EDWIN I. HATCH NUCLEAR PLANT, UNIT NO. 2

AMENDMENT TO FACILITY OPERATING LICENSE

Amendment No. 33
License No. NPF-5

ATTACHMENT TO LICENSE AMENDMENT NO. 33

FUEL TYPE 8DIB221(8DRL233)
MAXIMUM AVERAGE PLANAR LINEAR HEAT GENERATION
RATE (MAPLHGR) VERSUS AVERAGE PLANAR EXPOSURE
FIGURE 3.2.1-2

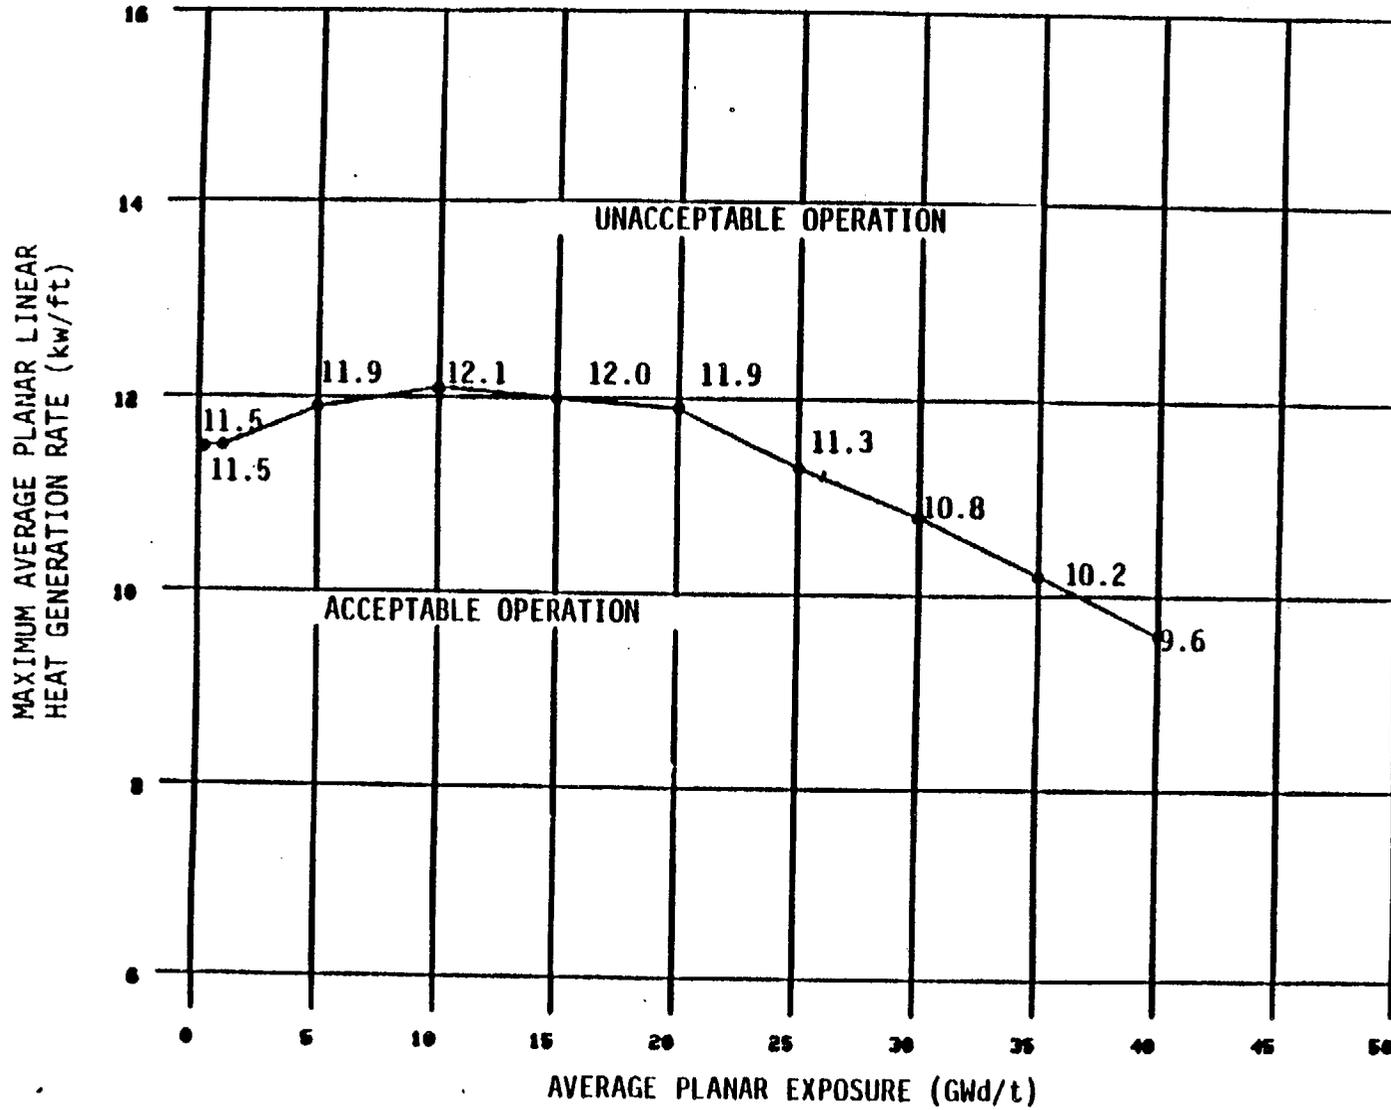
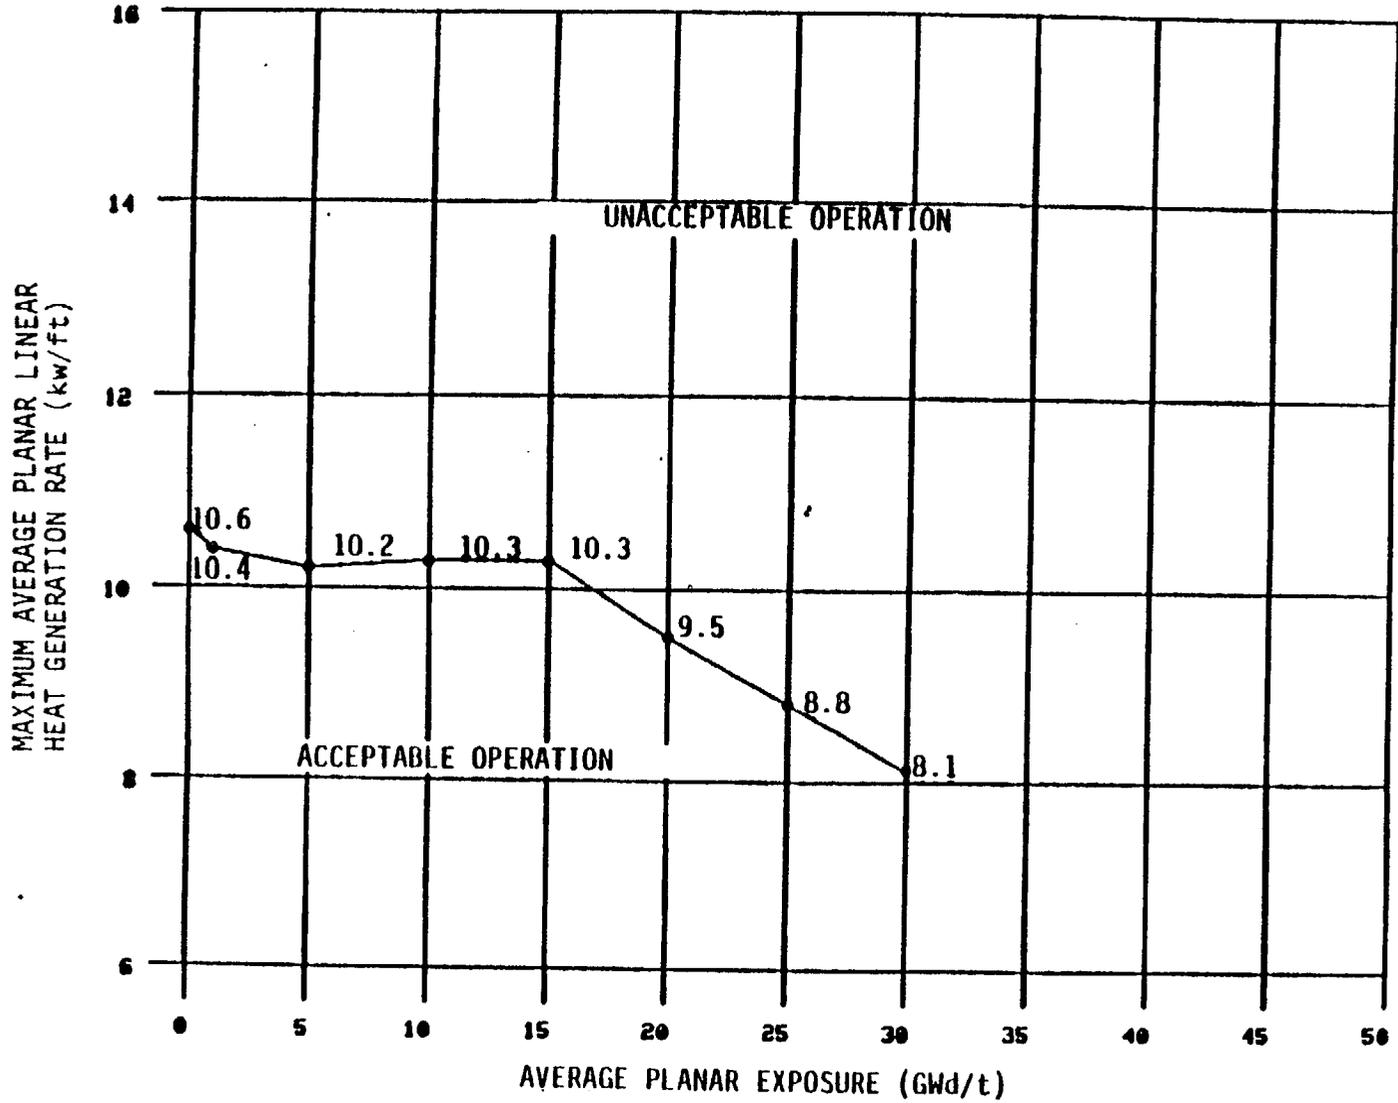
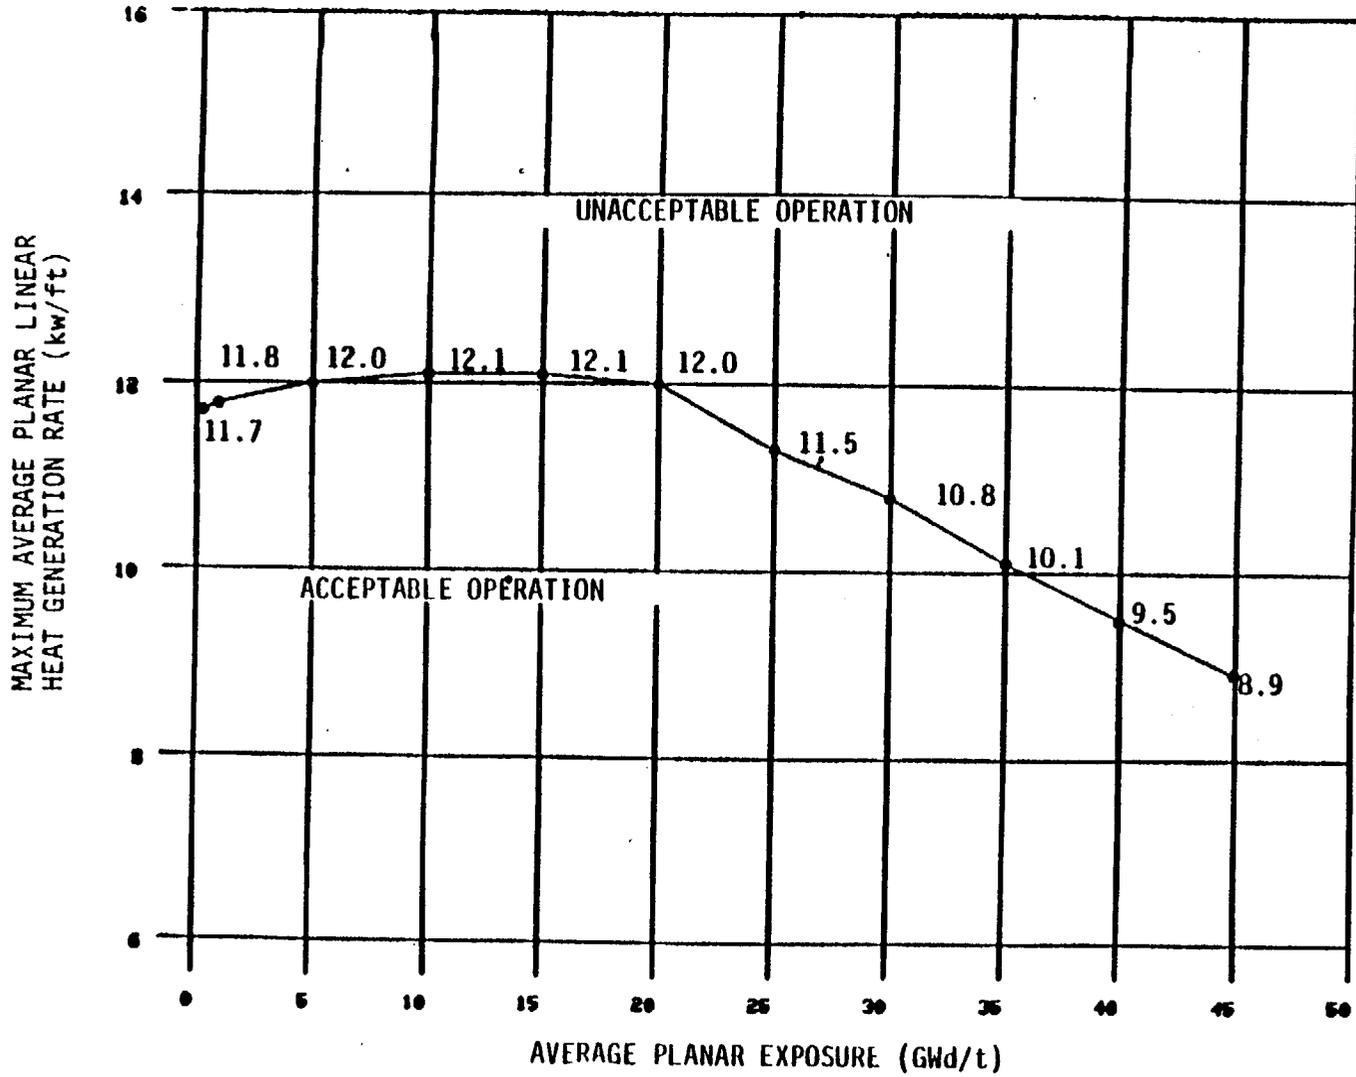
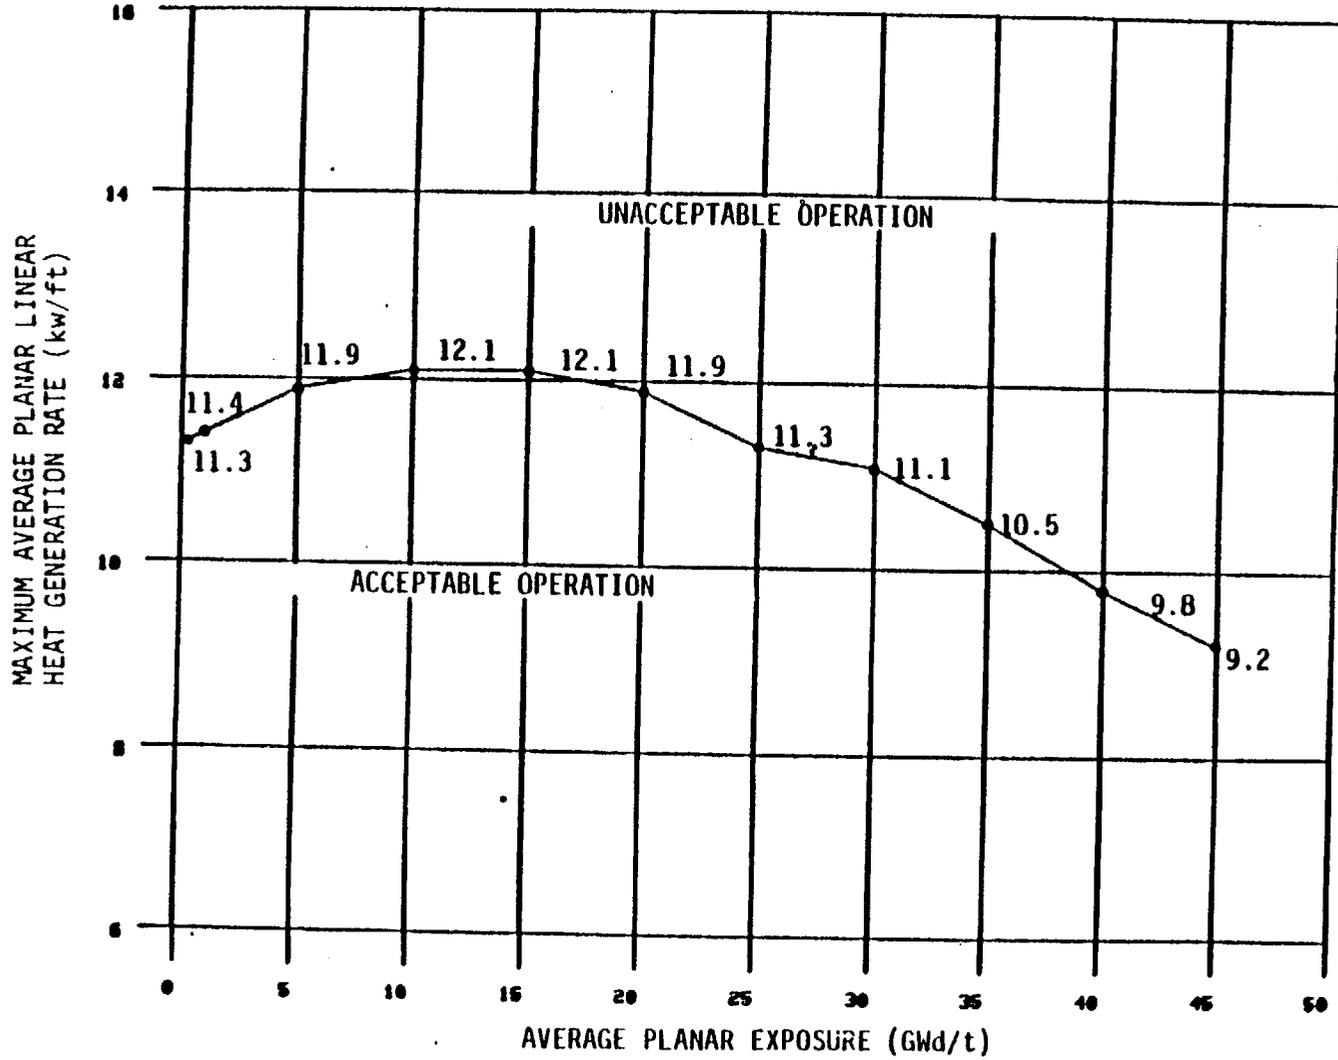
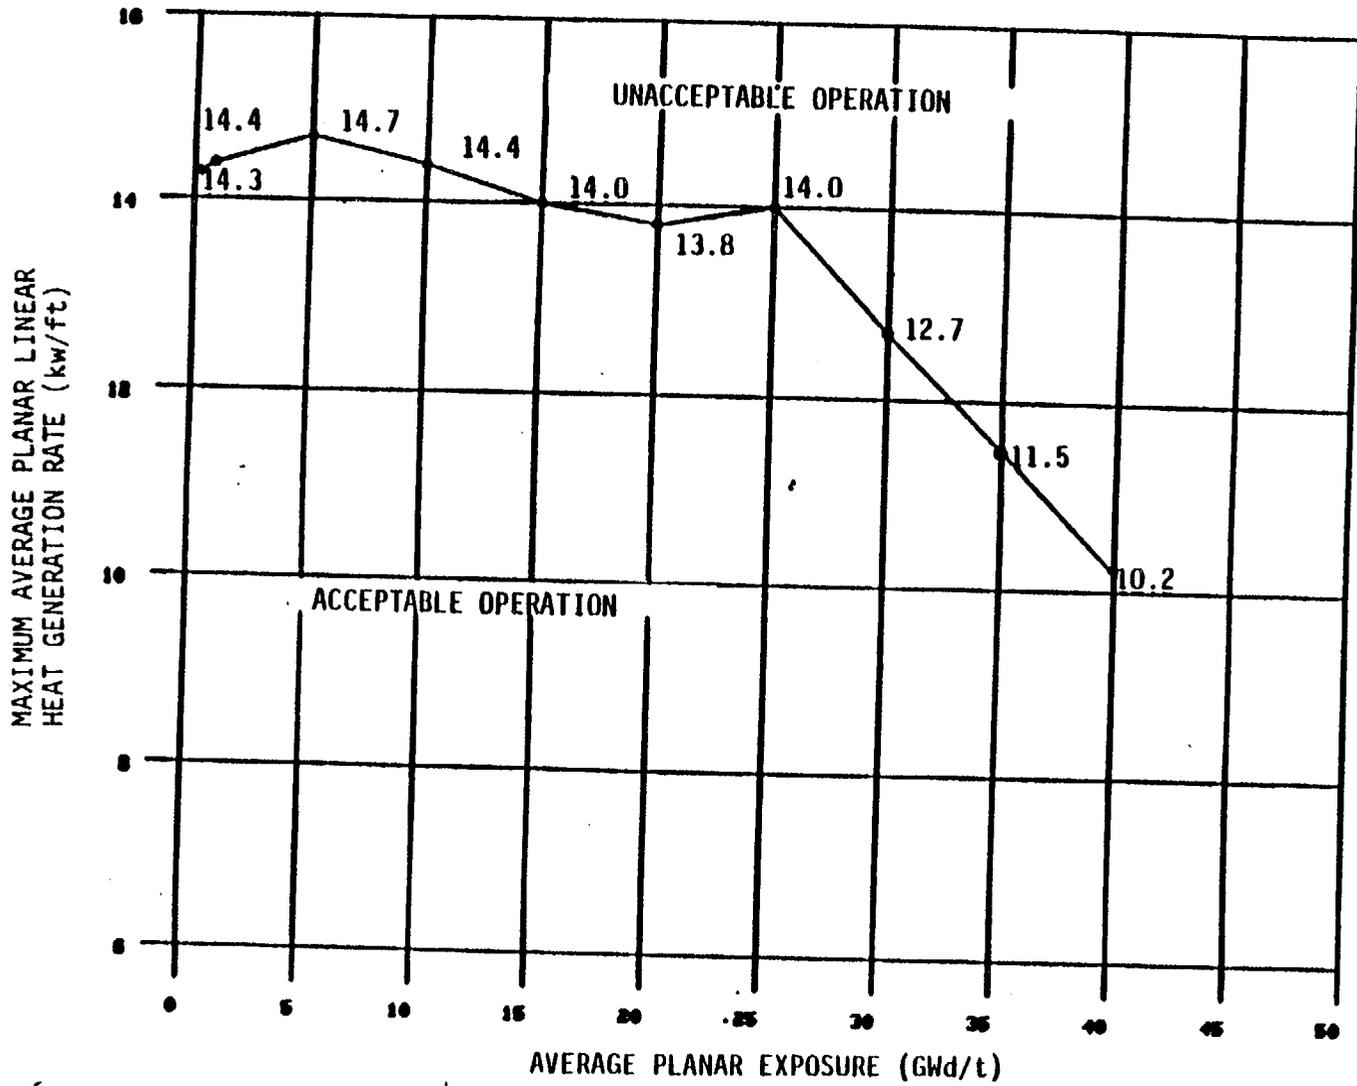
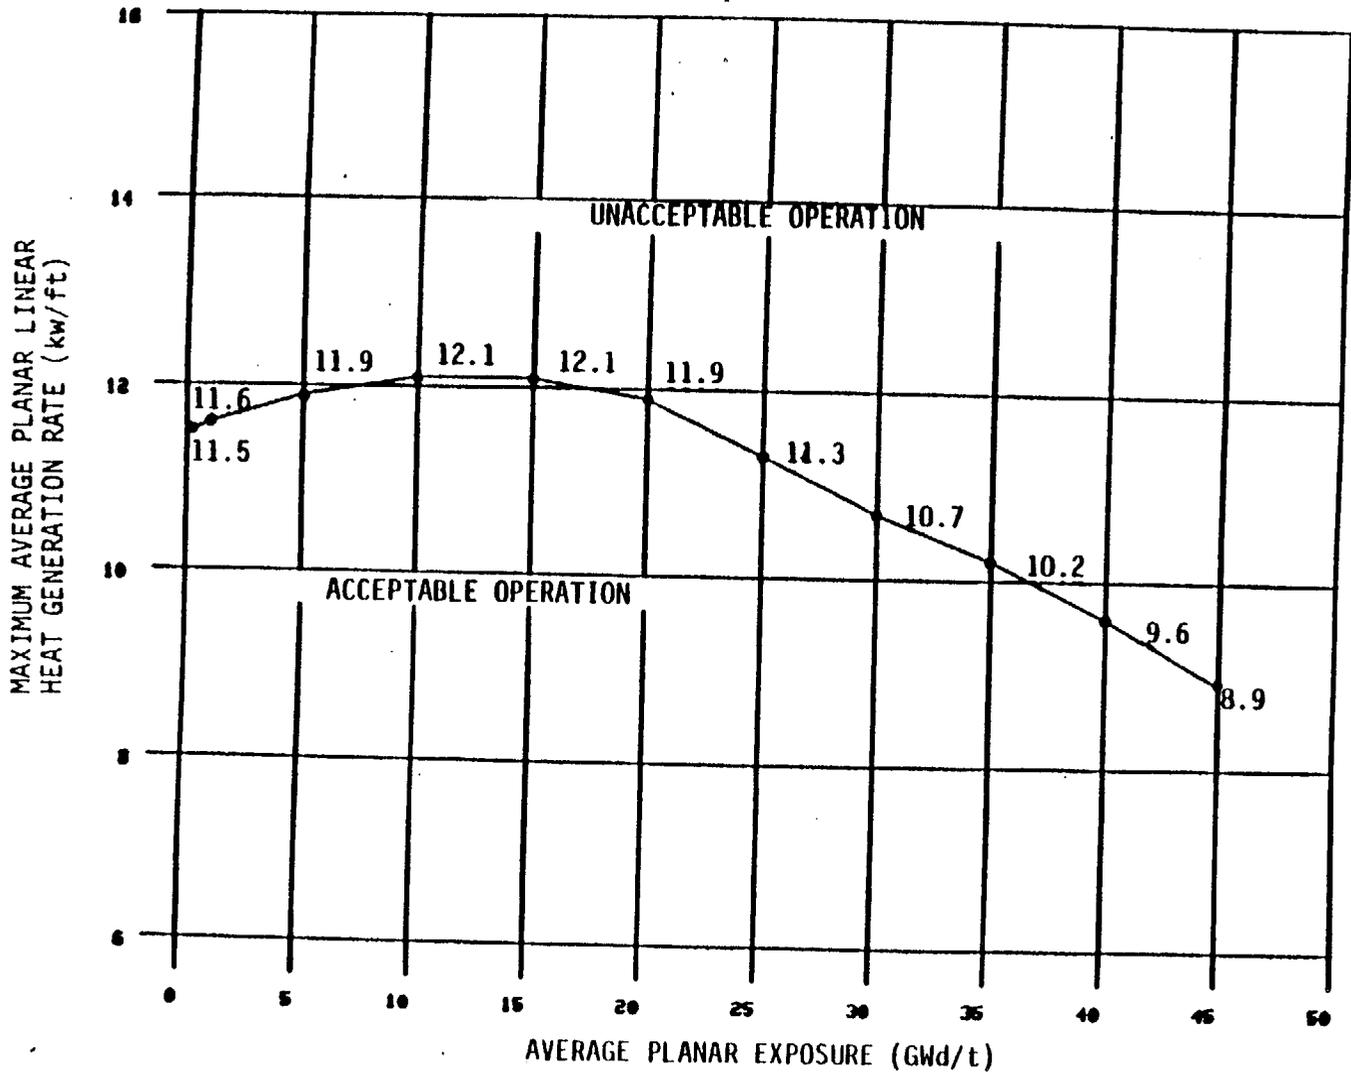
The licensee's submittal provided both new and revised MAPLHGR limits. The new MAPLHGR limits are for the fresh fuel (P8X8R).

The revised MAPLHGR limits for all fuel types have been extended to accommodate exposures to as much as 45 GWd/ST. These limits were generated by methods previously approved (Ref. 14). Although the methodology used is generically applicable for the MAPLHGR limit determination, we believe that the effects of enhanced fission gas release in high-burnup (i.e., greater than 20 GWd/MTU) were not adequately considered in the fuel performance model. In response to this concern, GE requested (Refs. 15 and 16) that credit for approved, but unapplied, ECCS evaluation model changes and calculated peak cladding temperature margin be used to avoid MAPLHGR penalties at higher burnups. This proposal was found acceptable (Ref. 17) provided that certain plant-specific conditions were met. The licensee has stated (Ref. 7) that the GE proposal is applicable to the Hatch Unit 2 analysis with the exception of three exposure points where the calculated peak cladding temperatures for Hatch Unit 2 fuel exceed those assumed in the GE analysis. In those three cases, the peak cladding temperature for the Hatch Unit 2 fuel is less than 20°F larger than the limiting temperature in the generic analysis. The licensee has also stated that a temperature change of less than 20°F (per 10CFR50, Appendix K, Section II.1.b) is not considered significant. We accept this conclusion and conclude that the MAPLHGR Limits proposed for Cycle 4 operation of Hatch Unit 2 are acceptable.
